Interpretation of Research on Fuel Fragmentation, Relocation, and Dispersal at High Burnup

Date Published: [Month] 2021

Prototypicality and Representativeness of Empirical Database	21
Discussion of Consequences and Consequence Modeling	22
Limitations of the Empirical Database	23
Summary and Conclusions	24
Acknowledgments.....	25
References	26
Appendix A: A Model for Predicting Dispersal	A-1
Appendix B: Summary of Peer Review Comments and Resolution	B-1

Figure 3 Measurements of percent of fuel fragments smaller than 1 mm and 2 mm as a function of burnup⁵

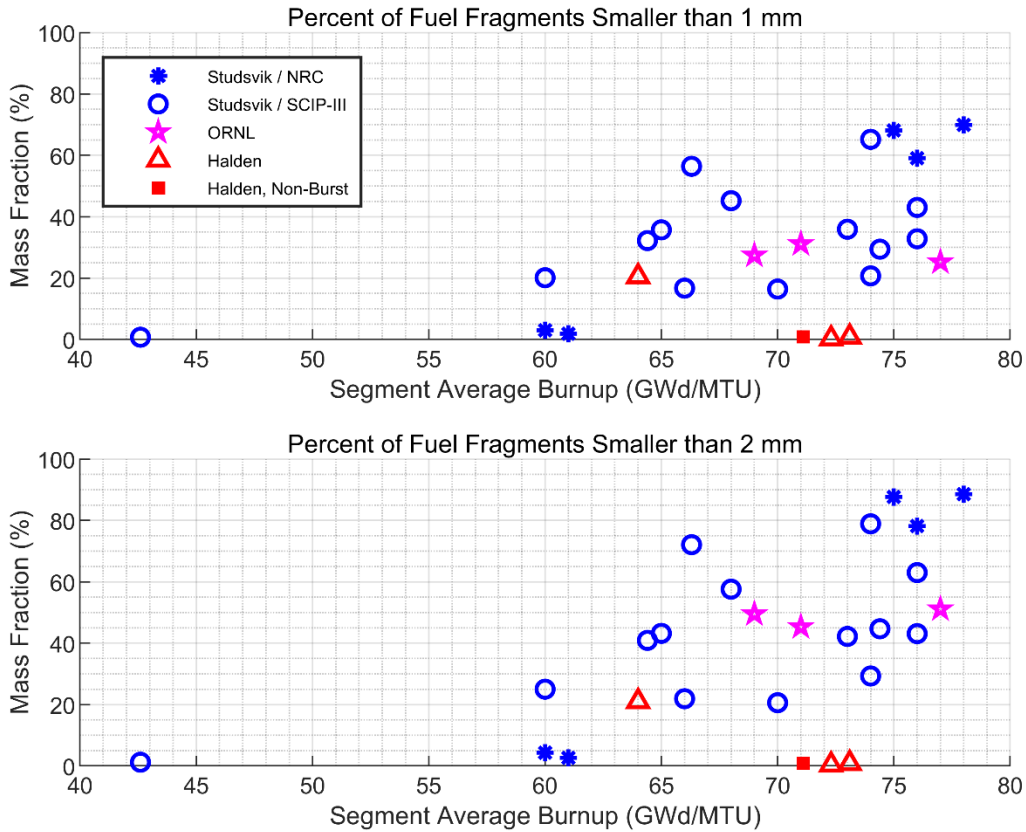
- Reviewers suggested that the RIL specify the basis for examining the mass of fuel fragments smaller than 1 and 2 millimeters. Text was added to explain that these size categories were considered for their indication of trends with burnup.

Figure 9 Illustration of fuel relocation and packing in the ballooned region

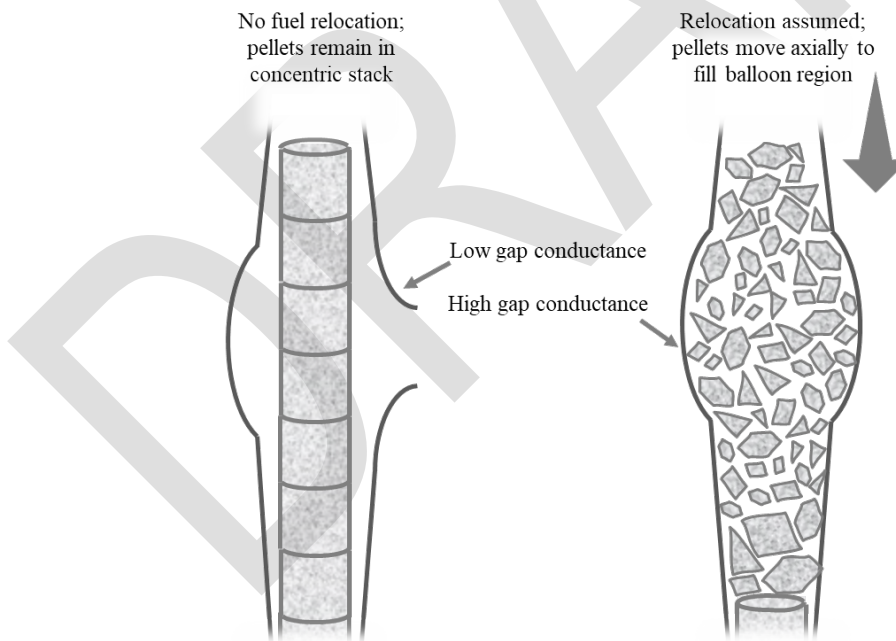
- Reviewers suggested removing references to low and high gap conductivity for cases without and with fuel relocation in Figure 9. This comment was not accepted.

Figure 11 Posttest Cs-137 signal and profilometry of SCIP III's 3V5-Q13 (Magnusson, et al., 2020)

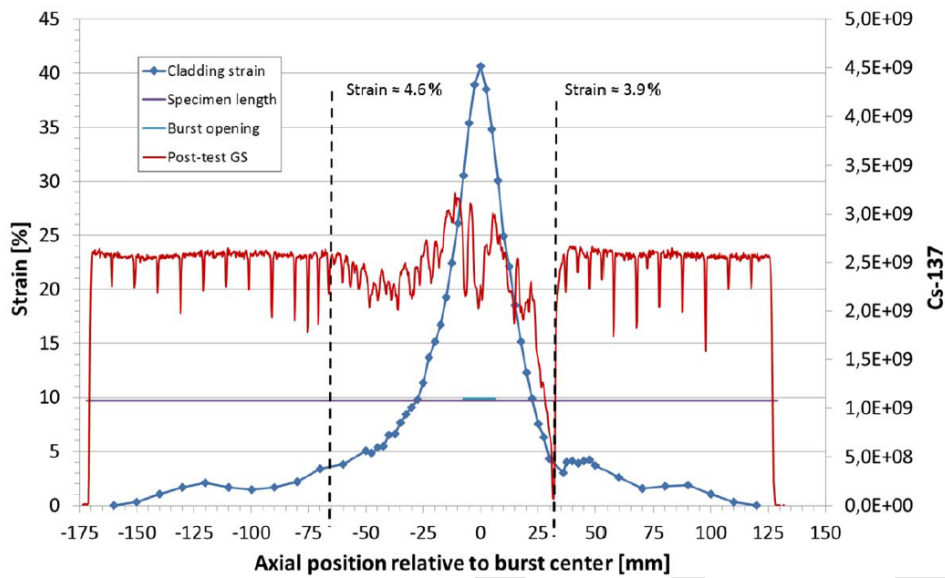
- Reviewers commented on whether self-shielding would significantly impact gamma scan—and thus packing fraction—results. Studsvik Cladding Integrity Program (SCIP) reports do not discuss whether ignoring self-shielding is an appropriate assumption. A sentence was added to state that more work is needed to evaluate the assumptions used to calculation packing fraction.

Figure 12 Packing fraction of 3V5-Q13 (Magnusson, et al., 2020)

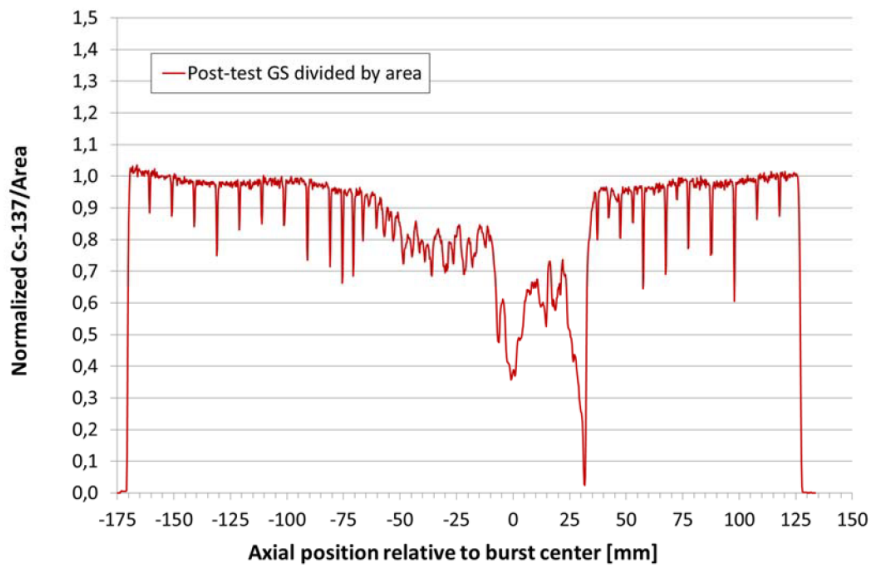
- Reviewers asked for clarification of how the axial distribution of packing fraction in Figure 12 relates to single values of the packing fraction cited for the various tests. This comment was accepted, and discussion was added about the particular test shown in Figure 12.
